GROWTH MANAGEMENT DEPARTMENT STAFF REPORT
VILANO BEACH TOWN CENTER OVERLAY DISTRICT
February 14, 2024 Public Meeting
VBTCDR 2024-01 – 176 Vilano Road Exterior Finishes

To: North Coastal Design Review Board
Staff: Teresa Bishop, AICP, Planning Manager
Date: February 7, 2024

Summary of Request: Applicant is requesting design approval for paint, landscape modification, entry doors, fences, and signage for an existing building.

ENTRY ELEVATION

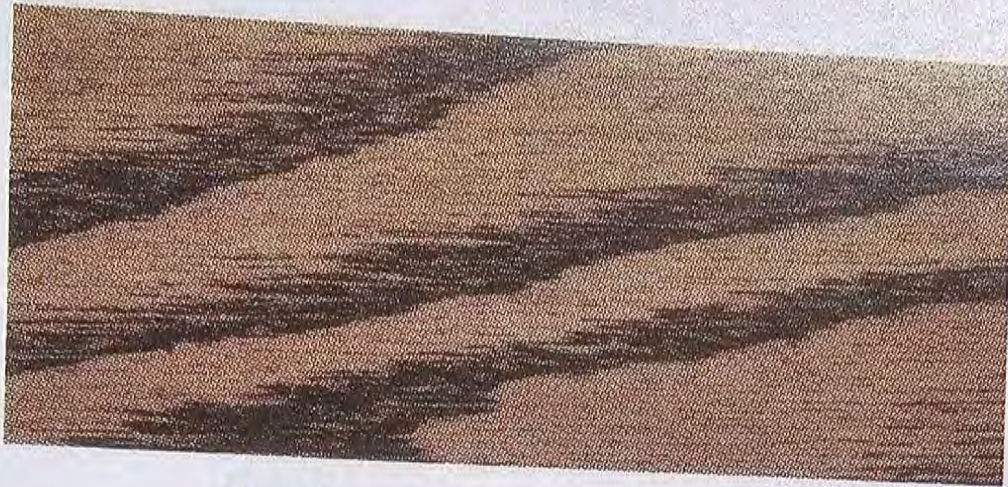
The Applicant has provided a color pallet for the DRB consideration and approval. The rendering show the details and use of the colors on the existing building. The colors appear consistent with the Vilano Beach Town Center. The applicant has requested:

Cotton White SW 7104 for the building
Shamrock SW 6454 (dark green) for the panels
Kingdom Gold SW 6698 for the panel accent
Dark Walnut SW 2716 for the new entry doors.
